SANTA ANA WATERSHED PROJECT AUTHORITY  
INLAND EMPIRE BRINE LINE REACH V  
REHABILITATION AND IMPROVEMENT PROJECT – PHASE 2

**ADDENDUM NO. 1**

INLAND EMPIRE BRINE LINE REACH V REHABILITATION & IMPROVEMENT PROJECT PHASE 2 DETAILS - 3
--

PROJECT NO. FILE NAME:	7616.0004
DRAWING NO.	D-3
SHEET NO.	12 OF 13

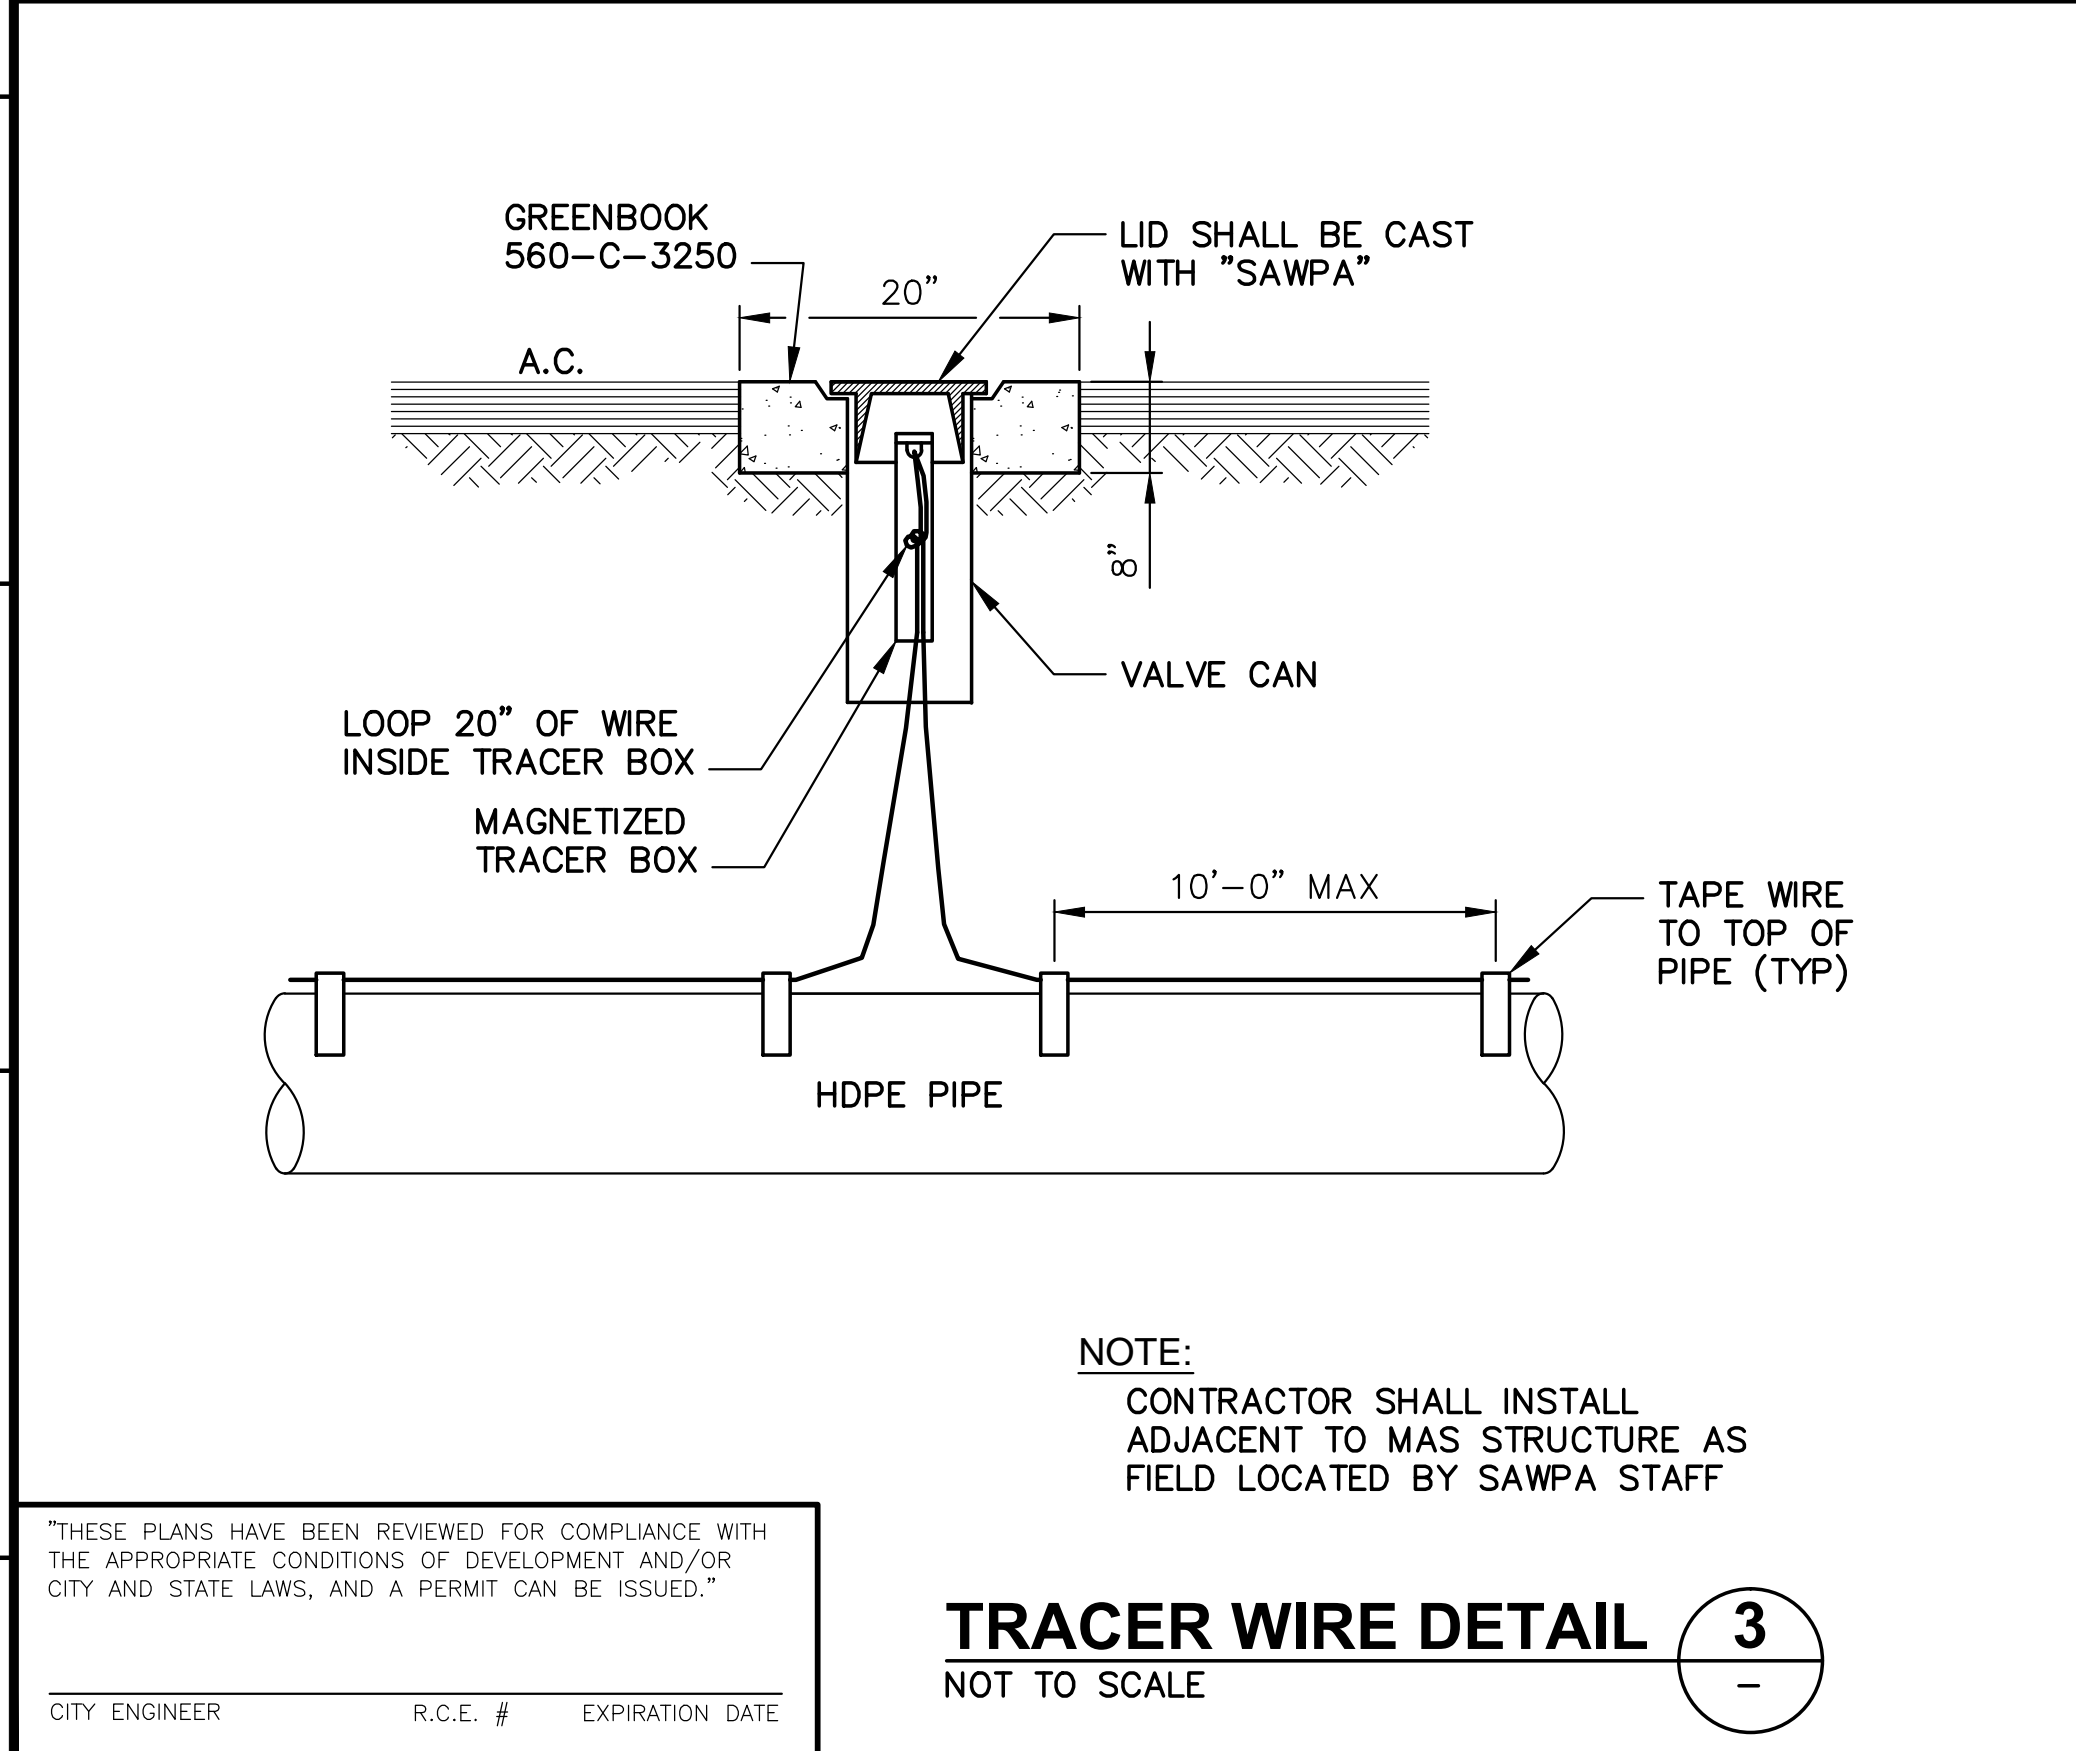
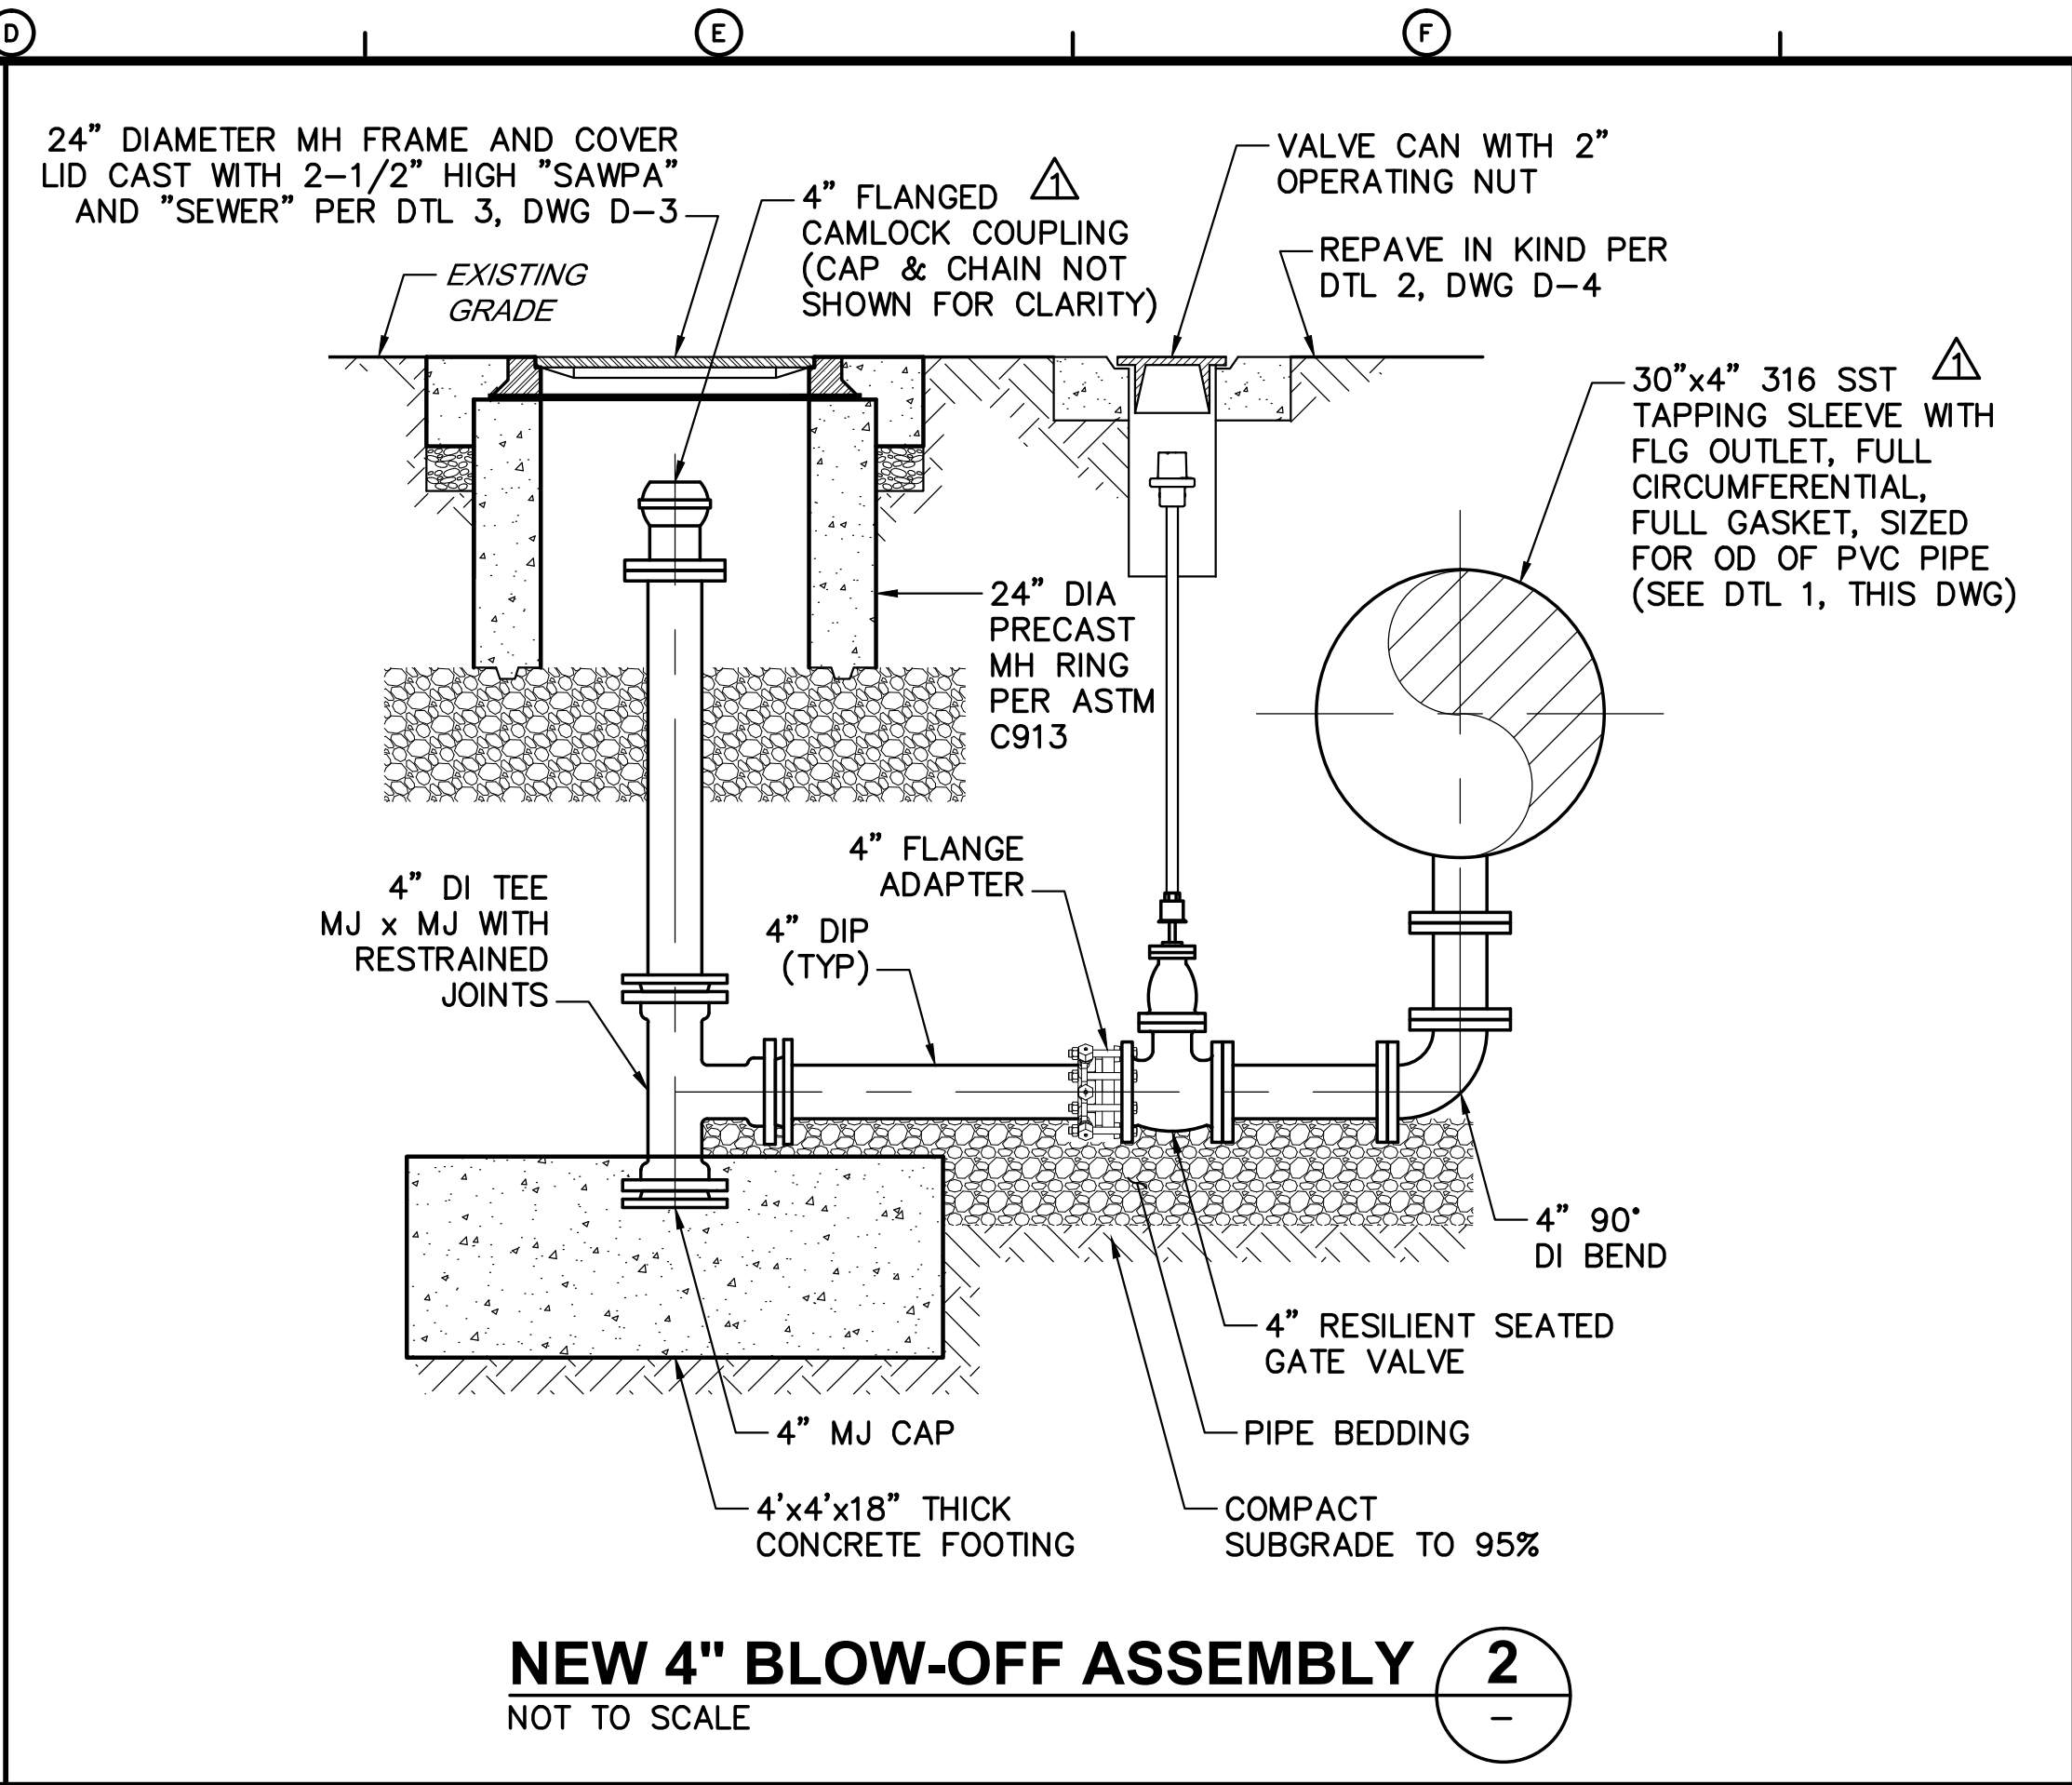
6. The following drawings shall be replaced with the attached revised drawings, indicating drawing revision 1 with a triangle.
  - a. Sheet D-3, in its entirety
7. Note 7 of Detail 1 on Sheet D-4 shall be changed to read: "Contractor shall furnish and install geotextile wrap (Mirafi 140N, or approved equal) around the pipe zone where the Contractor cannot obtain the required pipe zone compaction. Contractor shall coordinate with the Owner or his assigned representative to confirm the requirement for geotextile wrapping and install said geotextile as directed, at no additional cost to the Owner."

REV. NO.	DATE	DRWN	CHKD	CITY APPROVAL	DATE	REMARKS
1/13/16	CJD	DMM	-	-	-	ADDENDUM NO. 1: REVISED DTLs 1, 2, 4 & ADDED DIM SCHEDULE

HDPE FLANGE DIMENSIONS			
SIZE	OUTSIDE DIAMETER ("A")	BOLT CIRCLE ("B")	NO. OF BOLTS ("C")
24"	2'-8"	2'-5.5"	20
32"	3'-2.75"	3'-0"	28
